# SAFETY RECALL NOTICE

## QUICK-RELEASE LEVERS

Fig1: Quick Release not affected by this recall

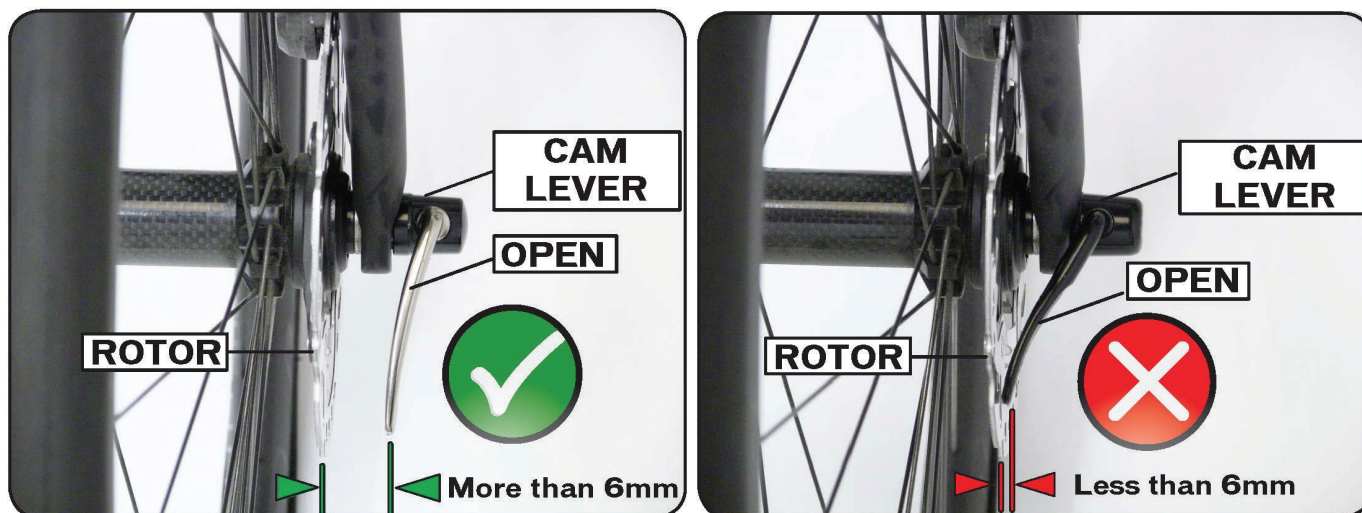
**Hazard:** Front-wheel quick-release cam levers that are improperly adjusted or left open during riding and do not meet the #2 Pencil Test below may potentially interfere with the front disc brake rotor, which could result in the rider losing control and sustaining serious personal injuries.

This is a Safety Recall Notice regarding all Model Year 2002 – 2015 Specialized bicycles equipped with front-wheel quick-releases and disc brakes where the space between the leading edge of the cam lever in its most open position and the disc brake rotor is less than 6 millimeters which is the equivalent of the width of a standard #2 pencil (the “#2 Pencil Test”). Please visit [www.quickrelease.com](http://www.quickrelease.com) for a visual demonstration of the #2 Pencil Test.

**Remedy:** Stop riding the affected bicycle immediately and bring it to an Authorized Specialized Retailer, which will replace the affected quick-release free of charge. For any inquiries, see your local Authorized Specialized Retailer or contact Specialized Rider Care at:
